**Subject: Cold Weather Starting Problems****Application: 1988-89 900 Models with EZK Ignition**

CATEGORY	
Engine	
SECTION 3	PAGE 6
ISSUE 03/91-0093	CODE 271

Supersedes S.I. 01/90-1208

Figure 1. 4-pin connector at the power stage.

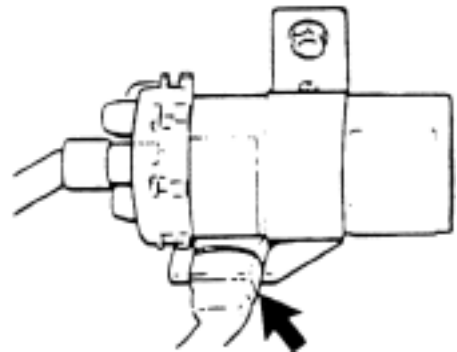
1988-89 900 models with EZK ignition system (B2021 engine) utilize a power stage integrated with the ignition coil. The ground wire for this power stage has a relatively long travel resulting in the possibility of enough ground circuit resistance to affect cold weather engine starting.

To shorten this ground path, a procedure has been developed to install a new ground wire from the power stage directly to the right-hand inner fender. This procedure also includes replacement of the hard plastic cover over the coil with a rubber boot for improved moisture protection.

1. Disconnect the 4-pin connector from the power stage (see Figure 1) and peel back the connector's protective boot.
2. Push pin No. 2 (wire 648, black) back out of the connector and cut off the terminal. Tape this wire back to the harness.
3. Install the new ground wire from the kit through the sleeve of the boot and into pin 2 of the connector. Refit the boot over the connector.
4. Connect the 4-pin connector to the power stage.
